Standing Policy Committee on Planning and Urban Development (PUD) reference # PUD2020-0164

RE: Proposed North Hill Communities Local Area Plan

Excerpt from:

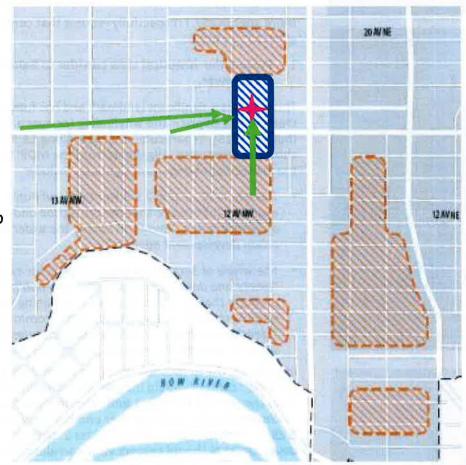
To address this concern, I respectfully request amendments to the plan in Chapters 1 and 2 to protect the view corridor down 1A ST W to Balmoral School. In addition, City Council may wish to have additional view corridors to the tower recognized such as views from key intersections along 16th Avenue such as those from 8th Street and 4th Street.

In addition, I request an amendment to the Heritage map in Appendix C of the plan to help ensure that views to this historic landmark are considered in future planning decisions.

Area proposed to be included as a Heritage Planning Area to protect historic view corridor.

1428 1A ST NW, renovated c.1913 2-story home, immediately adjacent to proposal for 6-storeys

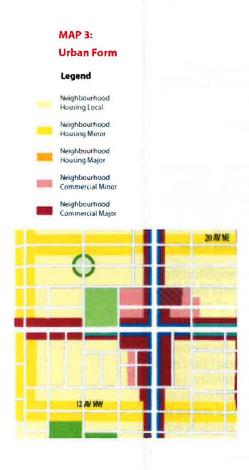
The third concern is that these parcels back onto single family back and side yards. Without even a lane to help create separation, the overviewing from higher elevations will create sightlines into many private spaces and would materially interfere and affect the use and enjoyment of these properties. In addition, the building massing of 6-storeys immediately adjacent to character homes such as the recently renovated c.1913 home shown in the picture to the left does not respect the existing neighbourhood character.

The change to the plan that I respectfully request is to amend Map 4: Building Scale to change the areas shown in blue on the bottom of this page from Low (up to 6 Storeys) to Limited (up to 3 Storeys).
